Enclosure 2 to U-602196 Section 3.6 Page 245 of 476

SUPVETILIANCE REQUIREMENTS (continued)	Enclosuse 4 to U 602364 Section 3.6 Page 29 of 87
SURVEILLANCE REQUIREMENTS (continued) SURVEILLANCE	FREQUENCY
SR 3.6.4.1.3 Verify each (secondary containment) access door is closed, except when the access opening is being used for entry and exit (, then at least one door shall be closed).	31 days
SR 3.6.4.1.4 Verify each standby gas treatment (SGT) subsystem will draw down the (secondary containment) to \geq (0.25) inch of vacuum water gauge (in 6.1120) secondo	[18] months on a STAGGERED TEST BASIS
[within the frequired time timets o	y Figure 3.6.4.1-1.
SR 3.6.4.1.5 Verify each SGT subsystem can maintain > 10.256 inch of vacuum water gauge in the [secondary containment] for 1 hour a a flow rate = 14000 cfm.	[18] months on a STAGGERED TEST BASIS

DC Sources—Operating 3.8.4

3.8.6 Battery Cell Parameters

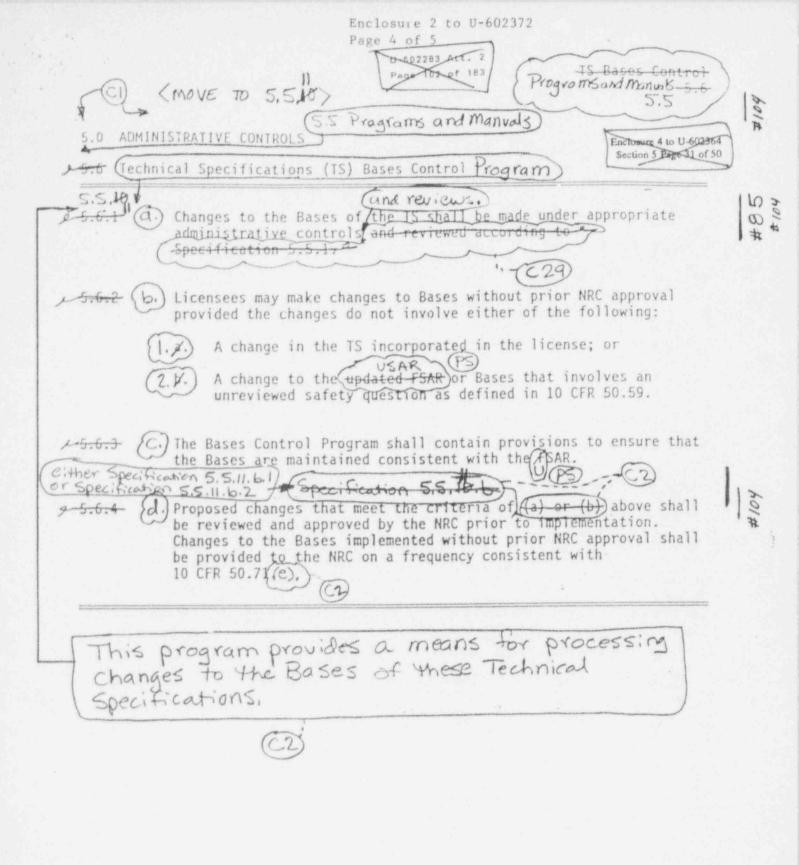
Battery cell parameters for the (Division 1, 2, and 2) e batteries shall be within the Category A and By limits of Table 3.8.6-1.

(battery is) APPLICABILITY: When associated DC electrical power subsystems are required to be OPERABLE.

LCO 3.8.6 Battery cell parameters for the Division 1, 2, 3, and 4 batteries shall be within the limits of Table 3.8.6-1.

APPLICABILITY: When associated battery is required to be OPERABLE.
